## ADDENDUM No. 1

**PROJECT TITLE:** Holy Cross Parish Office & Kitchen Renovation

**SUBJECT:** Mechanical & Electrical changes and/or additions

**HOLY CROSS PARISH OFFICE & KITCHEN RENOVATION**

#### 2.3 Electrical Drawing E1.02 – Ground Floor Electrical Plans

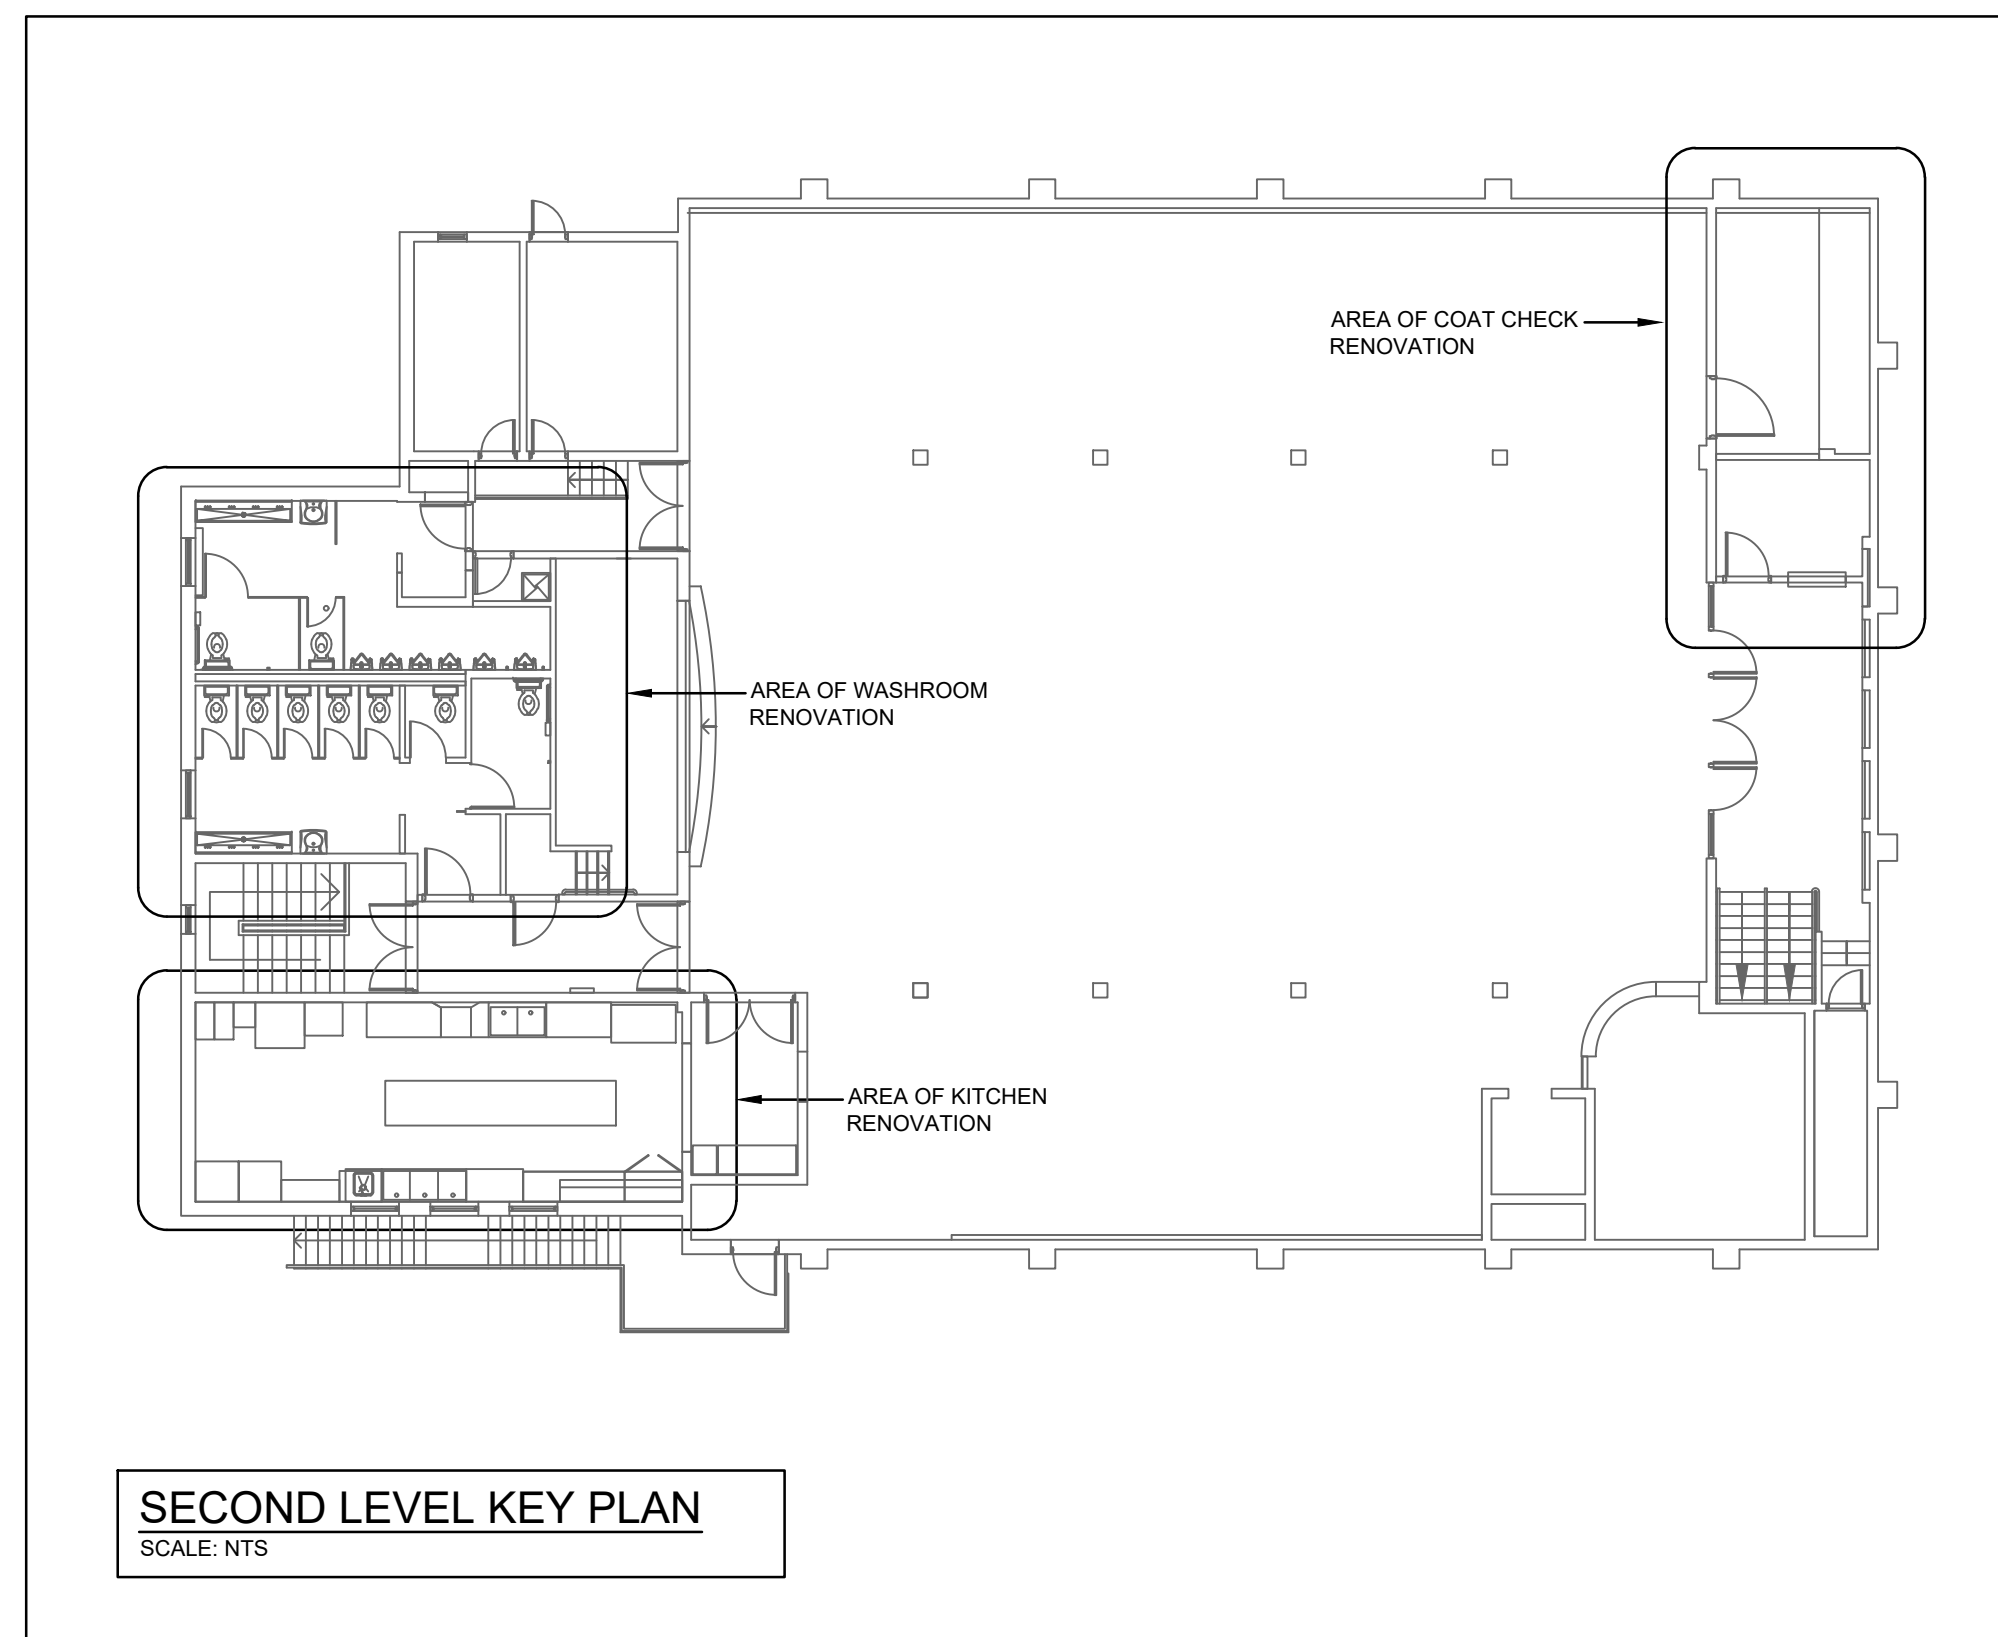
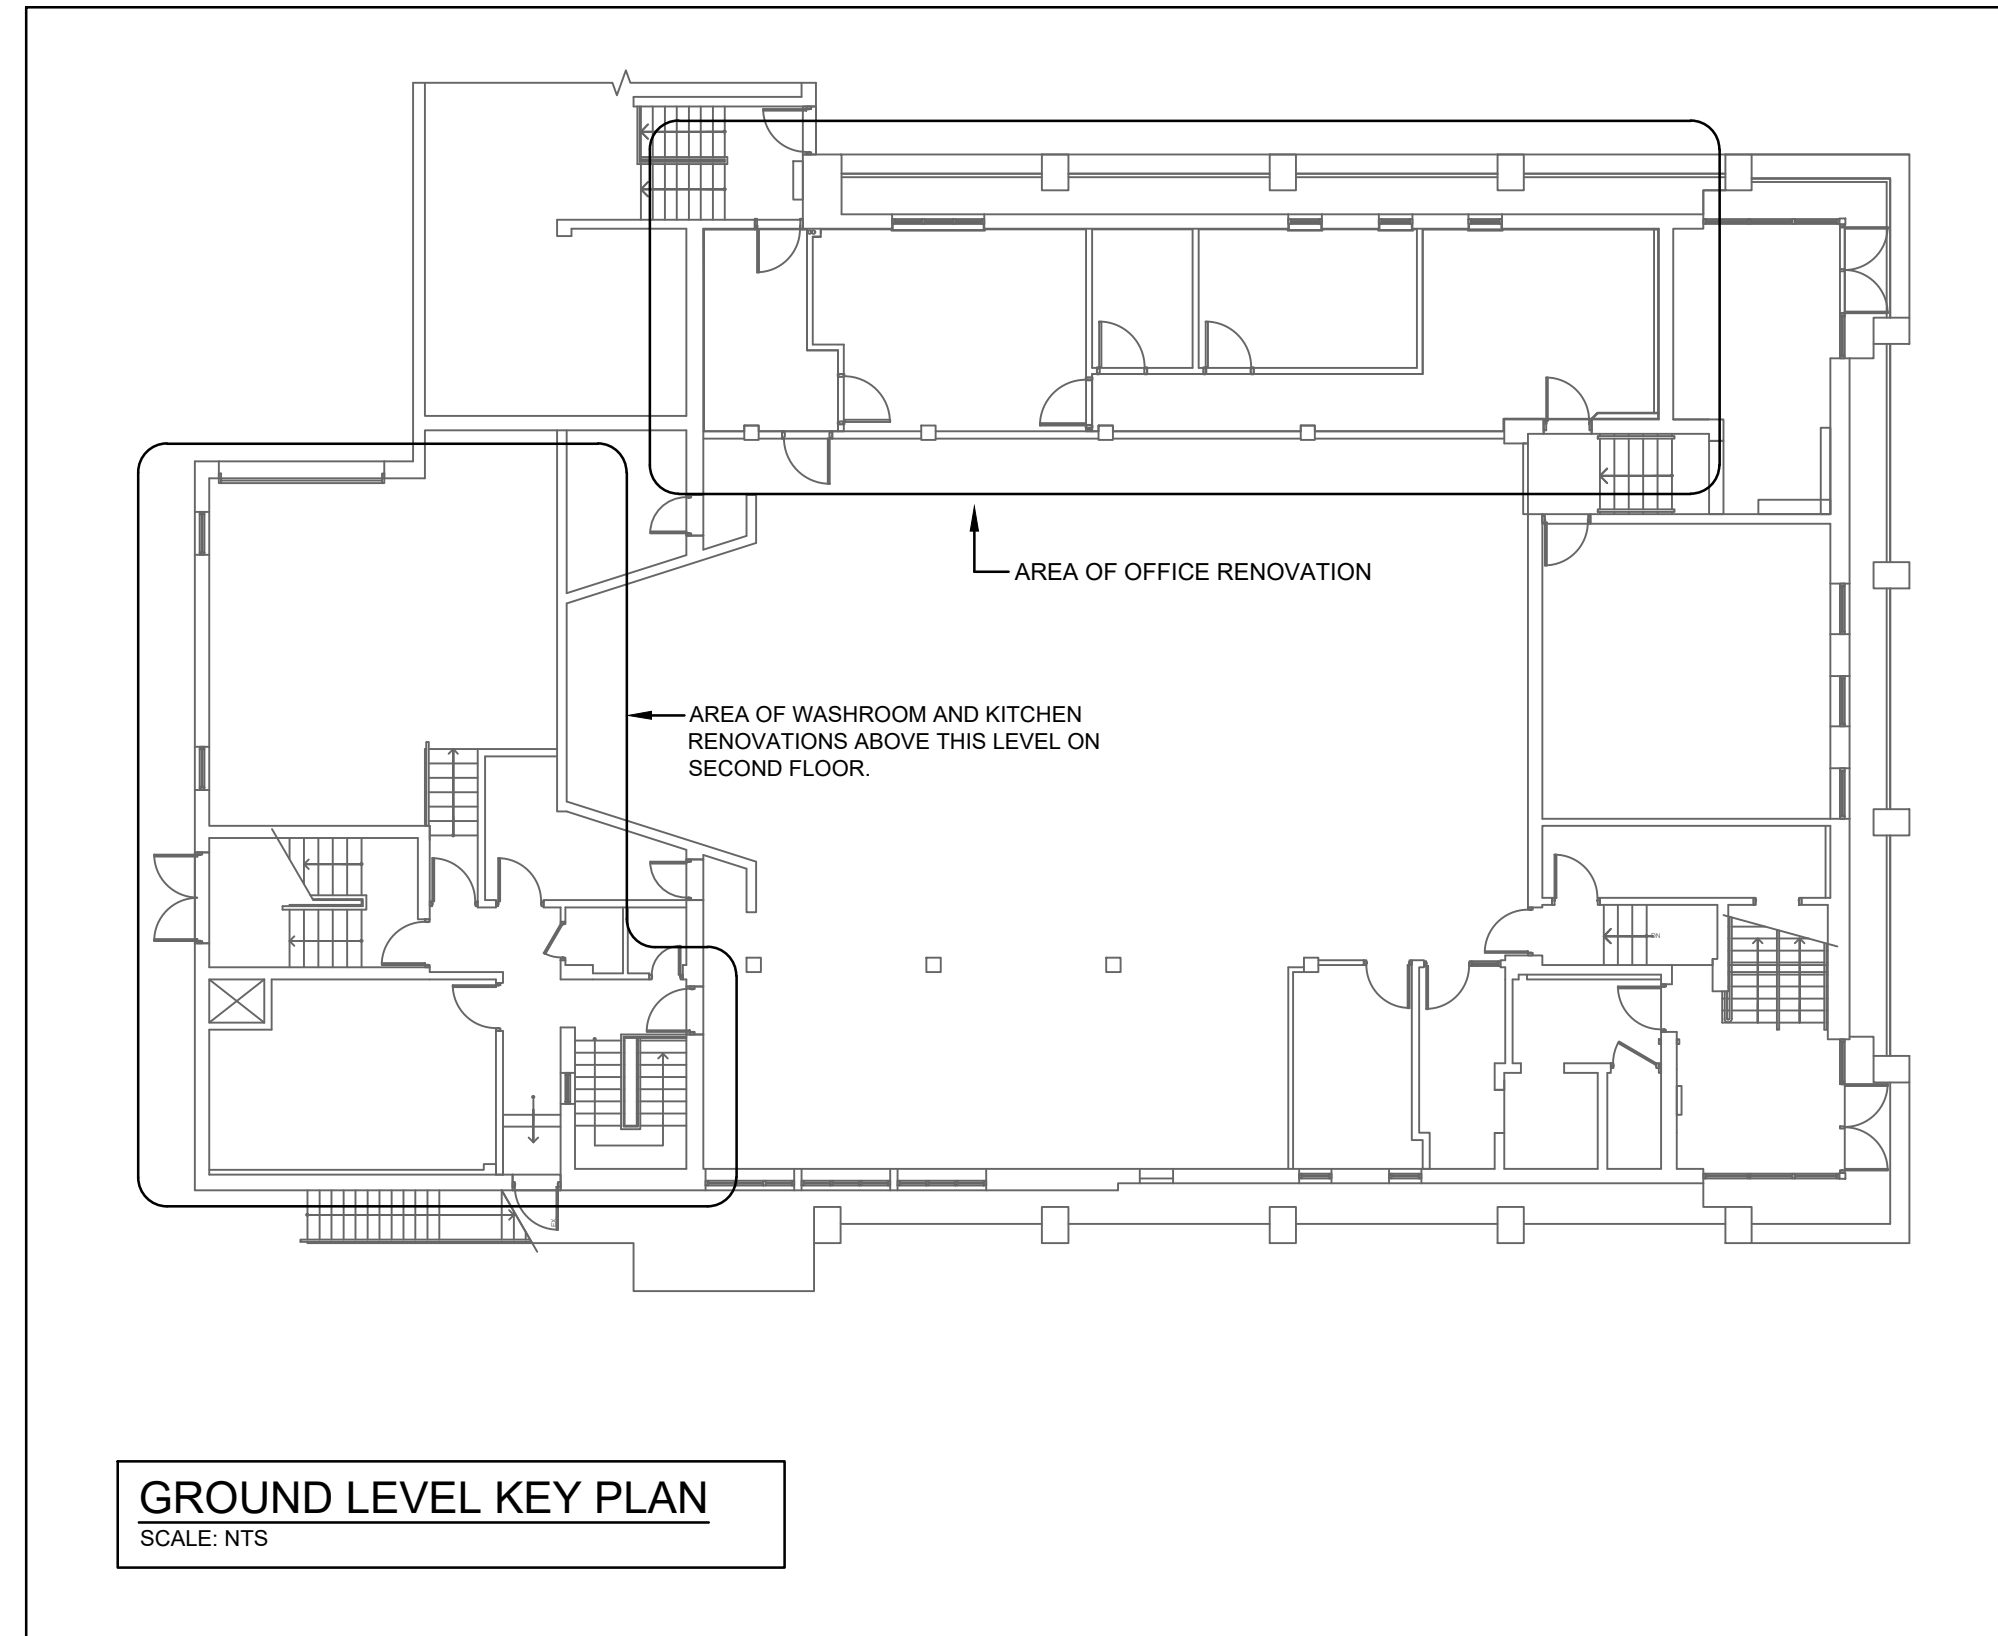
- Added Drawing Key Note #13 as indicated on revised drawings
- Added Door release button ('DR'), Electric Strike ('ES') and Door Intercom ('DI') as indicated on revised Power Plan.

**E0.01**

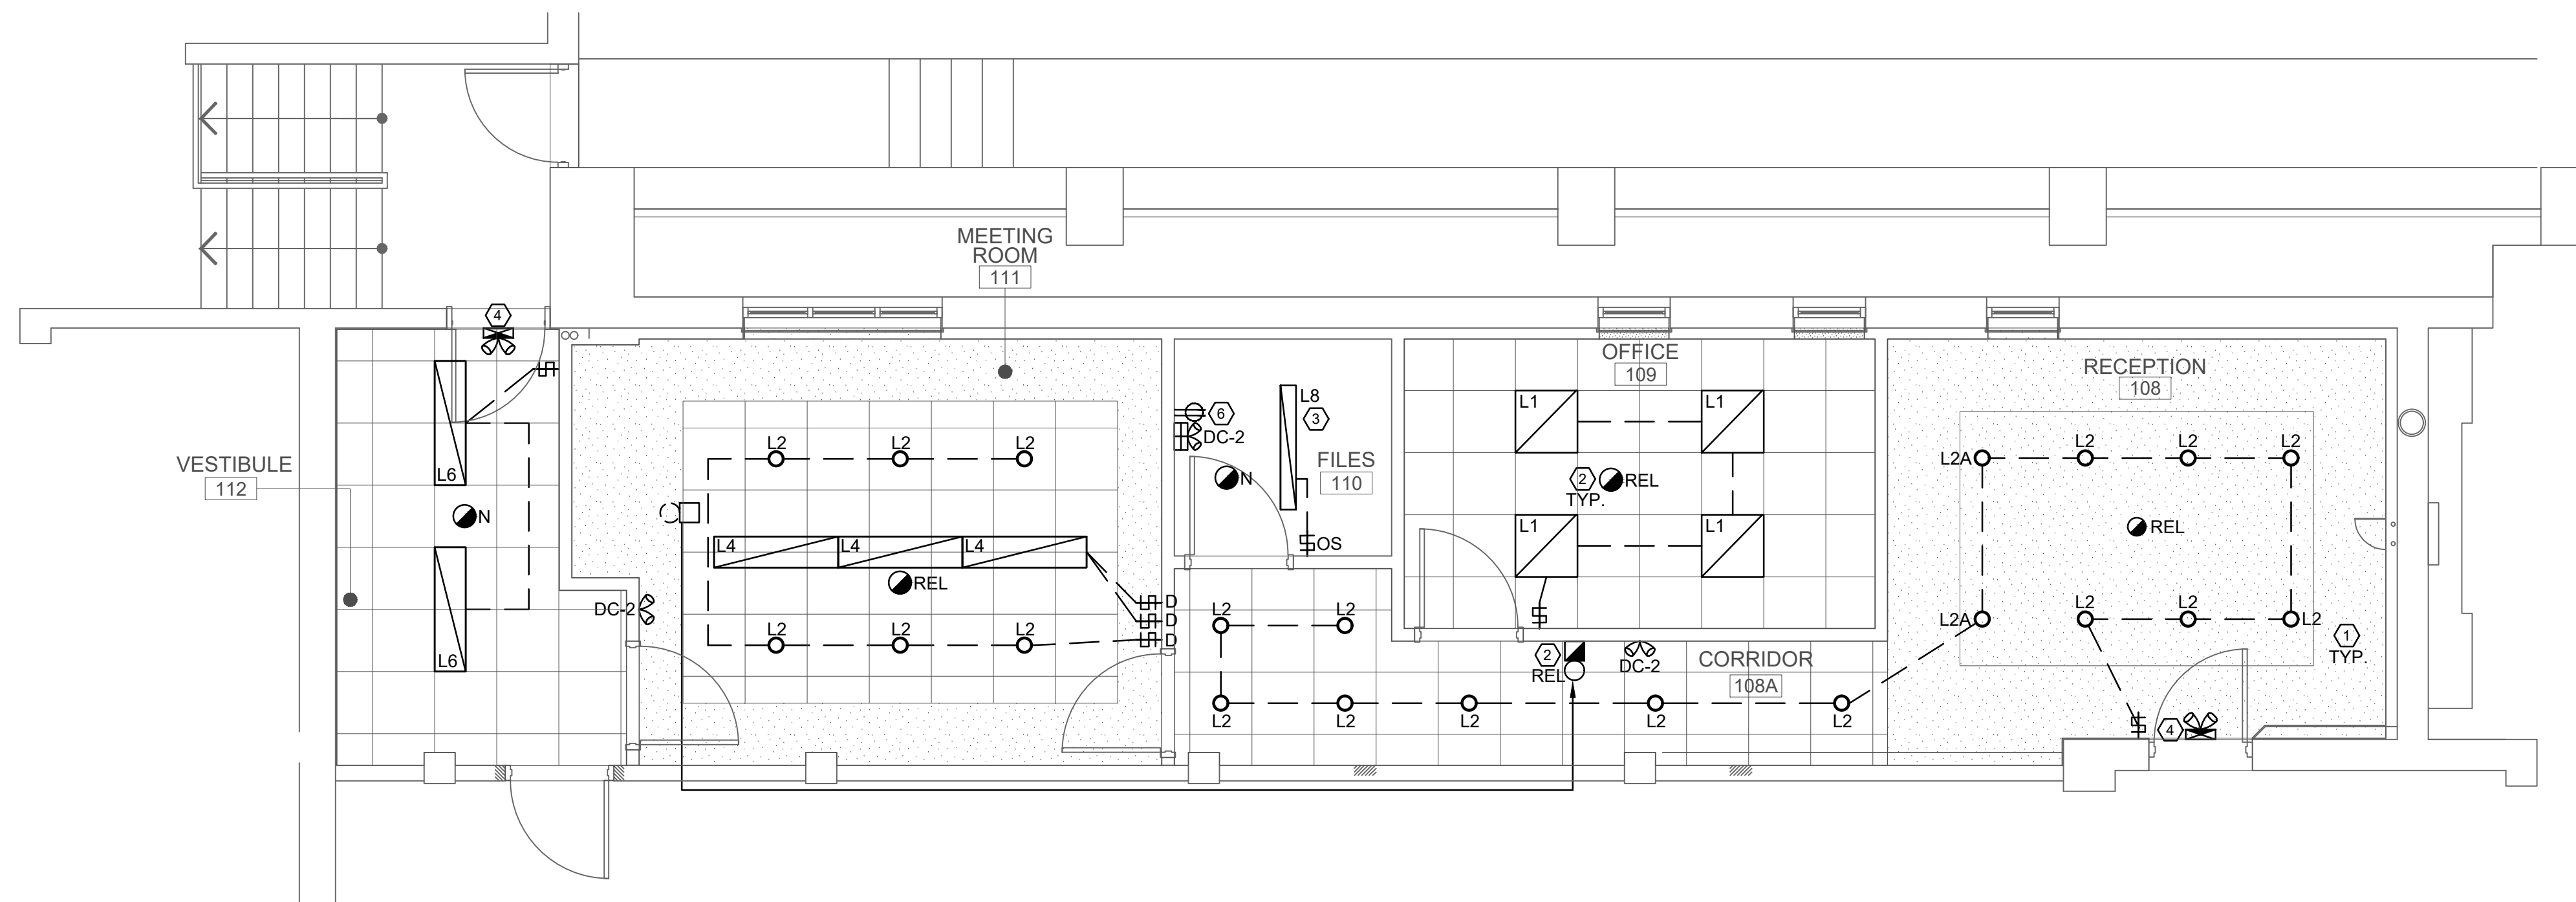
- Revised Miscellaneous Legend as indicated on revised drawings
